IN THE DRAWINGS:

<u>REMARKS</u>

Drawings

Fig. 1

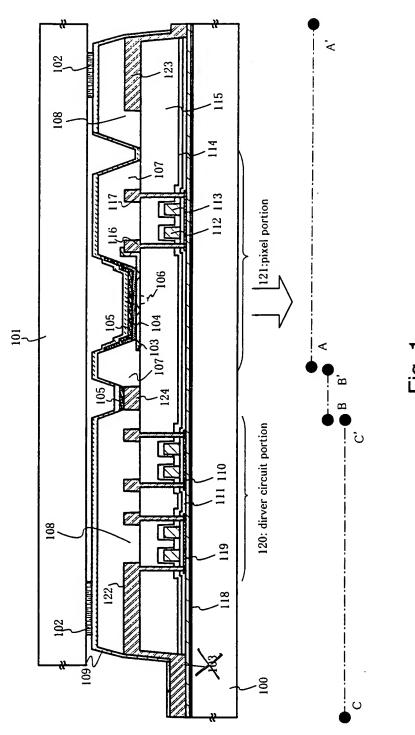
In the Office Action, the Examiner objects to Fig. 1 and states that the label 103 in the driver circuit portion on the first substrate is incorrect. Applicants are removing this label and therefore, respectfully request that this objection be withdrawn.

The attached sheet of drawings includes changes to Fig. 1 to delete the second

occurrence of reference number 103, in accordance with the Examiner's comment.
